NUMBER: 79-9

DATE: 6/6/79

- A. V-6 Outboard E-Z Shift Gear Housing Shift Cams and Cam Followers**
- B. Power Trim Pumps - Valve Body Mounting Screw Torque**
- C. Hard Starting - V-150 1979 Model**
- D. Water Pressure Gauge Kit - C-91-79250A1**

**C. HARD STARTING - V-150 1979 Model**

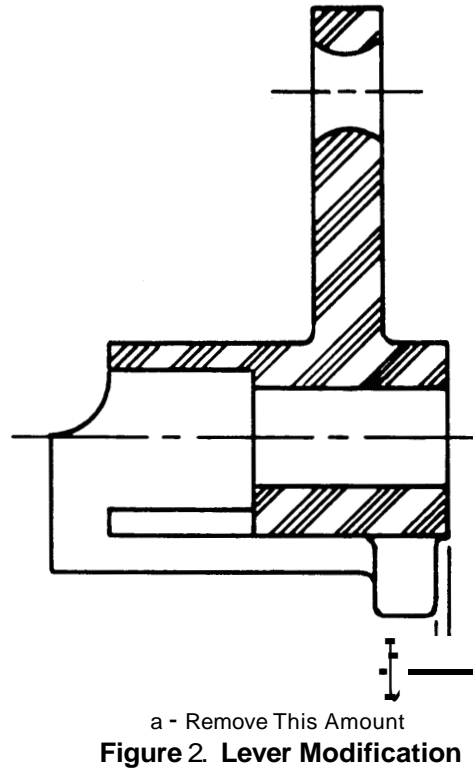
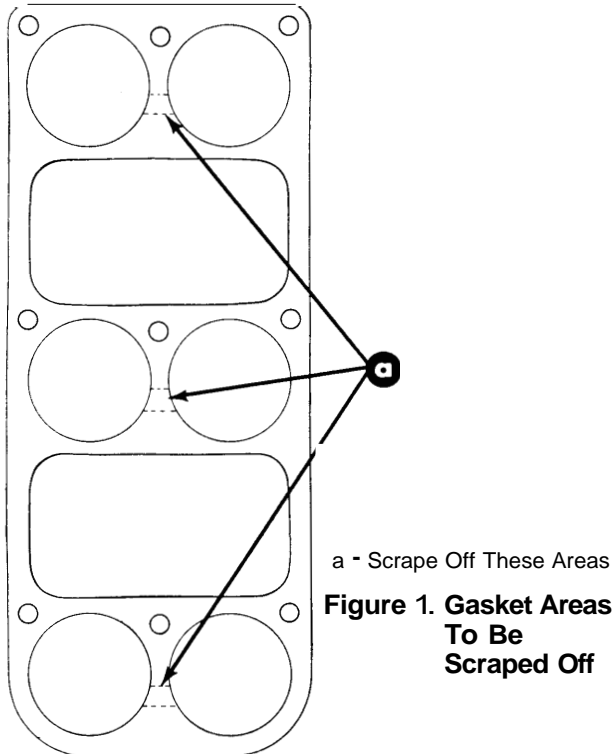
Hard starting has been experienced on some V-150 1979 engines that are equipped with WH-9 type carburetors. Since this carburetor cannot be primed by overpowering the fuel primer bulb, the following modifications may be required.

1. Remove the plate assembly from the carburetors and remove the choke shutters and Part No. A-73619 retainers. Care must be taken when removing the shutter screws, since they are Loctited and staked to prevent loosening.
2. Scrape off the area of the outermost carburetor to plate gasket in the area where it has swelled into the choke shaft slot. (Figure 1) **THIS AREA MUST BE FLUSH WITH THE ORIGINAL GASKET SURFACE.**
3. Remove the choke shaft and lever assembly from the choke plate and replace the windup springs with the new springs (A-24-88578). Preload these new springs only one-half turn.
4. Reinstall the choke shaft into the plate and fasten the shutter screws in place with Loctite No. 35 (C-92-59238). Be certain that the shutters are aligned properly on the shaft so that, when the shutter is closed, it is centered in the hole in the plate and does not bind.

5. The new spring is axially longer than the old spring and may cause the shutter and A-76129 lever to bind on the choke plate. If this occurs, then the lever must be modified according to Figure 2.
6. If none of the shafts bind, replace the A-73619 retainers. If these cause binding, that cannot be corrected by realignment, remove them permanently.
7. Install a A-19-90399 plug (choke plate) in the cavity between the choke shutters (Figure 3) of adjacent cylinders and the choke plate to carburetor gasket for each carburetor and replace the choke plate assembly. (Figure 3) Check for binding after installation.
